City of San Antonio
Development Services Department

Re: **Bloomfield Heights Subdivision**

MDP # 003-10

The Development Review Committee has evaluated the **Bloomfield Heights Subdivision** Master Development Plan, or **MDP # 003-10**. Enclosed is an accepted and signed copy of the MDP for your files. However, please note the following conditions:

BLOOMFIELD HEIGHTS SUBDIVISION
MASTER DEVELOPMENT PLAN 003-10
PLANNED UNIT DEVELOPMENT 10-003 - MARCH 2010

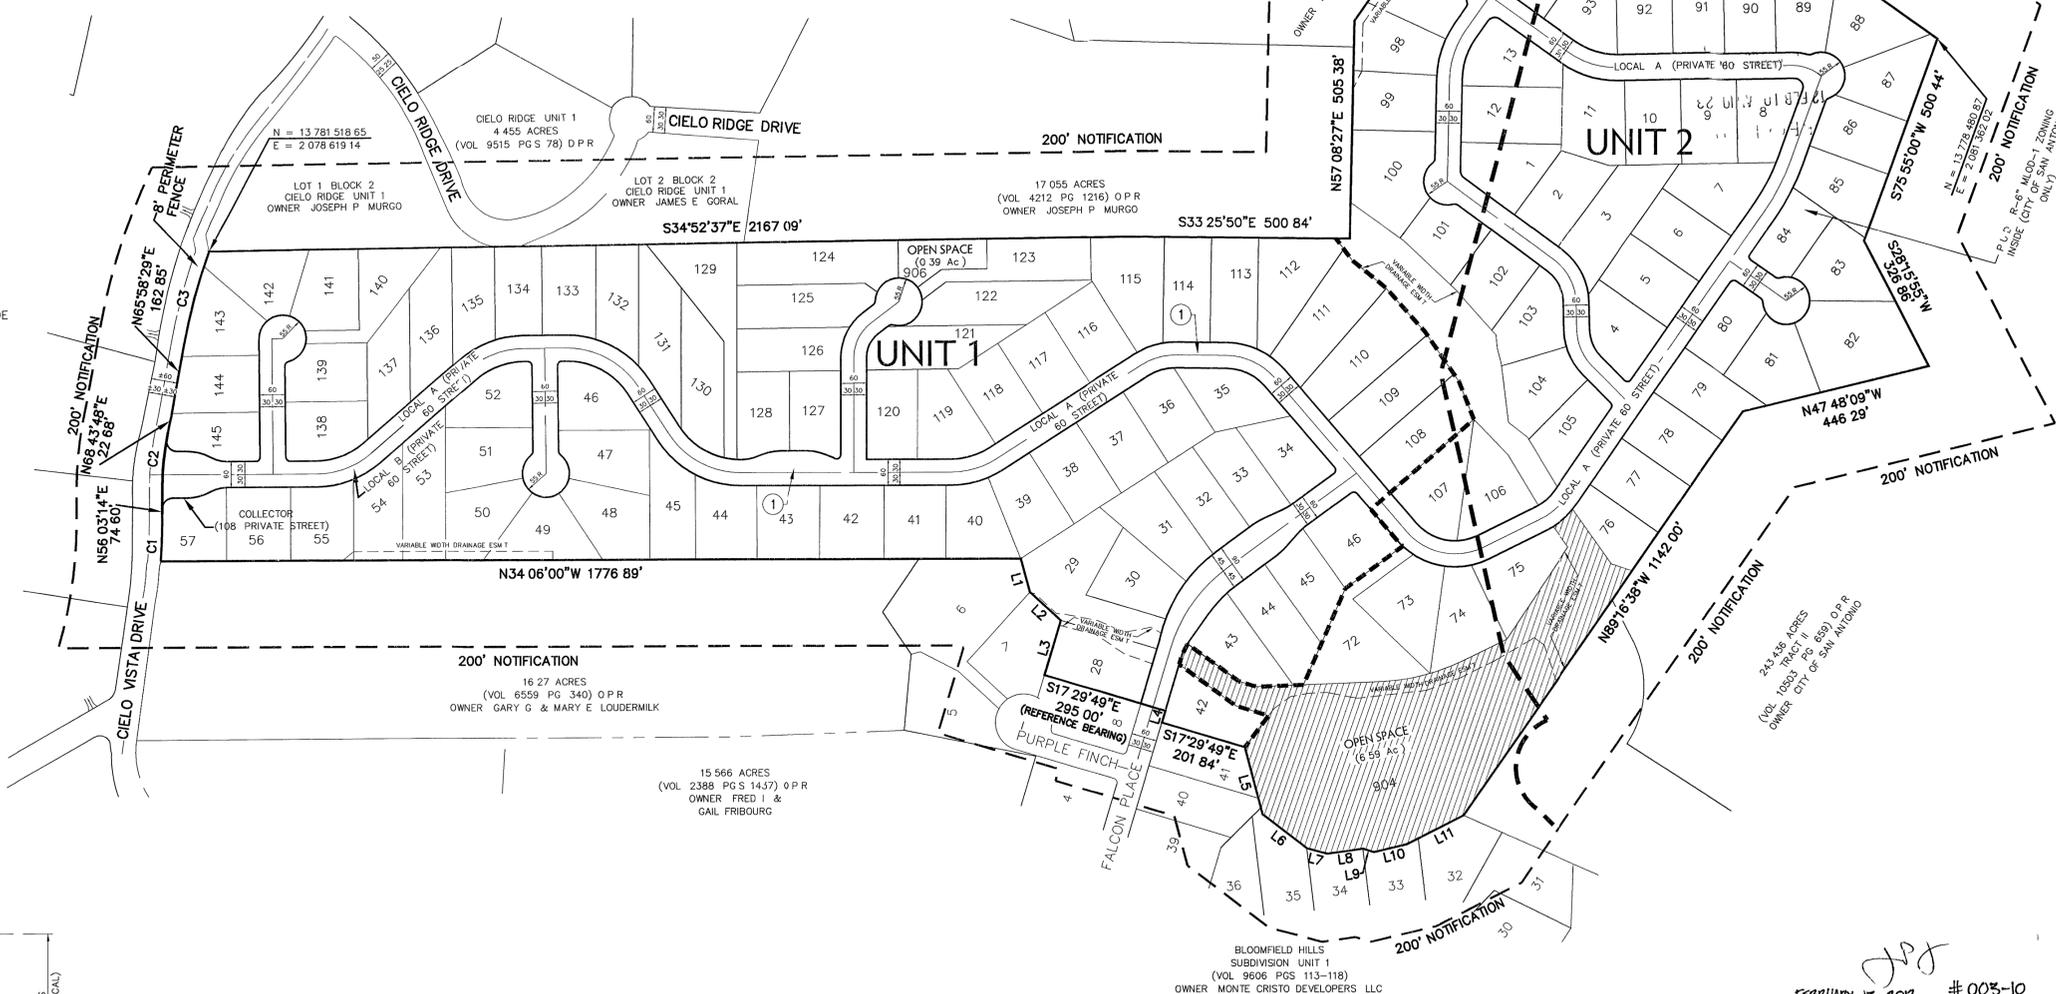
It will be expected that all of the property depicted in the Master Development Plan including but not limited to floodplains, drainage areas, and open space shall be platted. All platting shall comply with the Unified Development Code (UDC), the City's Master Plan, Major Thoroughfare Plan, and all applicable regulations for the City of San Antonio.

Please note that this action by the committee does not establish any commitment for the provision of drainage, utilities, services or zoning of any type now or in the future by the City of San Antonio. In addition, it is suggested to work closely with the school district, so they can plan for the development accordingly.
